UNITED NUCLEAR
CORPORATION

SUBJECT: Amendment to SNM-33: Increased Storage Capacity of
Building 235

**UNITED NUCLEAR
CORPORATION
CHEMICALS DIVISION**

501. BUILDING 235 (REFERENCE DRAWING 3712-204)

FIGURE 26

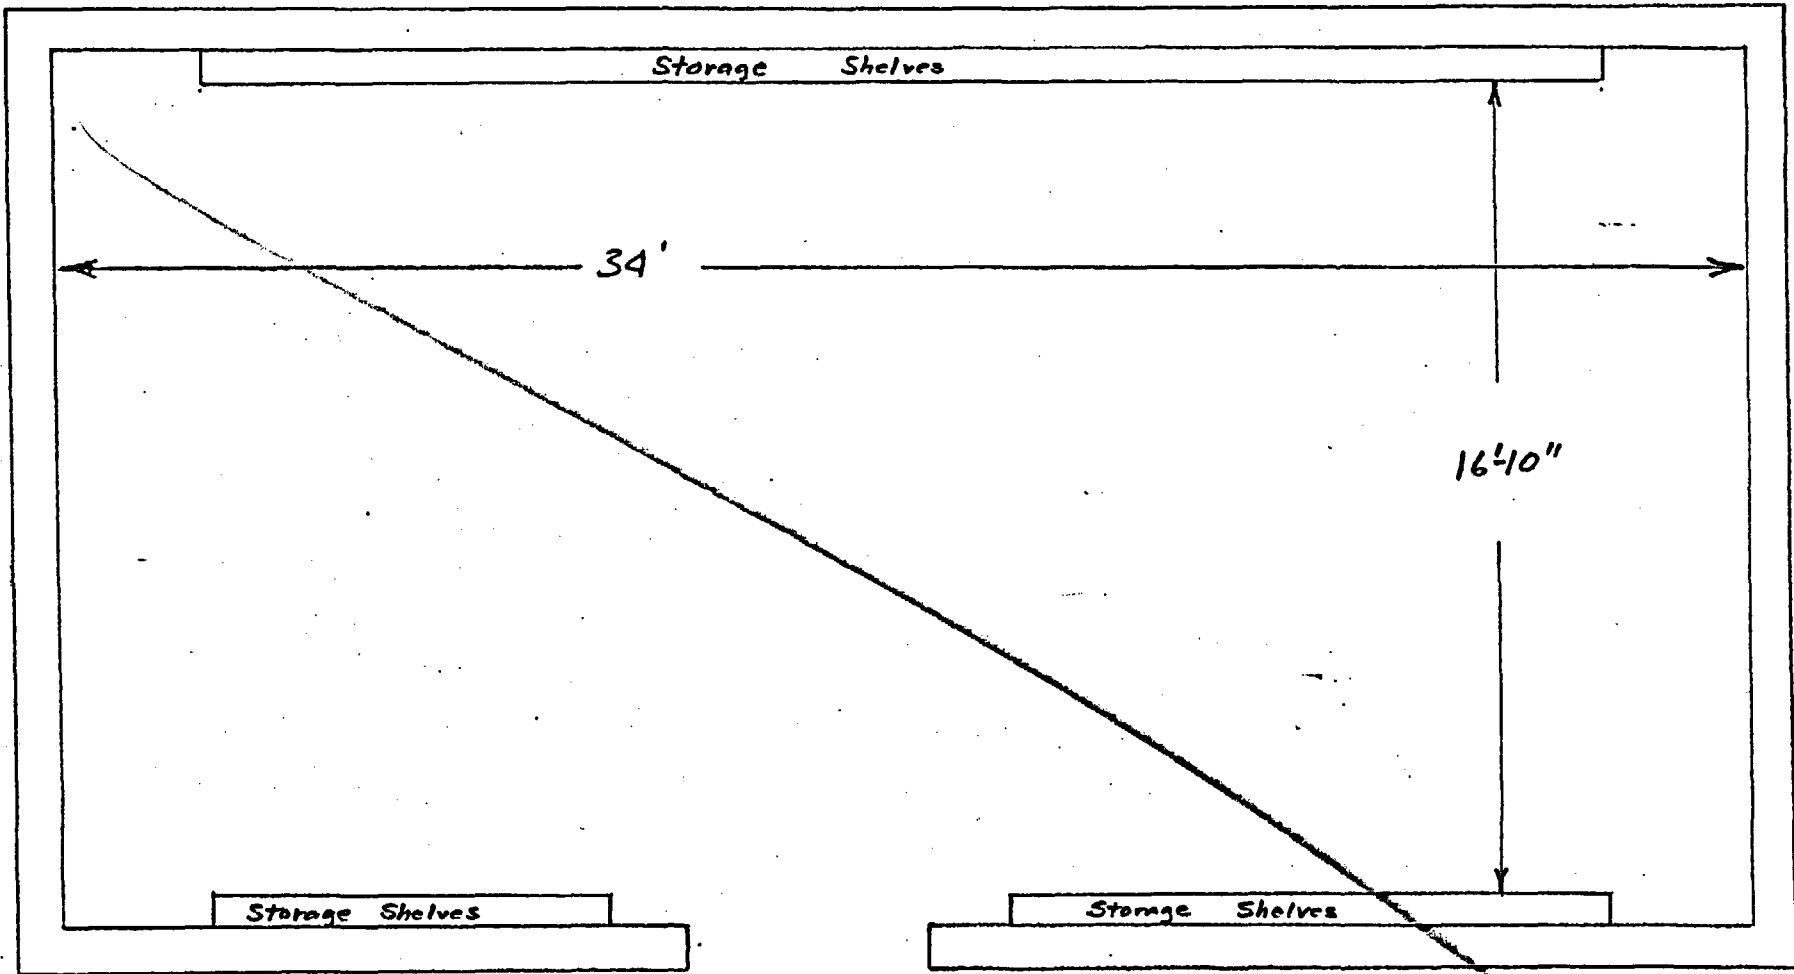
We have planned additional storage for Building 235 of our plant at Hematite, Missouri. This is to be accomplished by the addition of two concrete walls to the building. Details of this are described in Section 501, revised July 17, 1964 of "General Information Applicable to the Handling of Special Nuclear Material." A copy of this revised section is enclosed.

FIGURES 26 AND 27 SHOW A PLAN VIEW OF THIS BUILDING AND THE ARRANGEMENT OF STORAGE SHELVES. THE CONTAINER SIZES AND QUANTITIES STORED THEREIN ARE THE SAME AS LISTED IN PARAGRAPH 301.4.2. THE TOP TWO SHELVES WILL BE USED FOR THE STORAGE OF THE SHORTER CONTAINERS ONLY SUCH THAT THERE IS AT LEAST EIGHT INCHES SEPARATION TOP TO BOTTOM OF THE CONTAINERS.
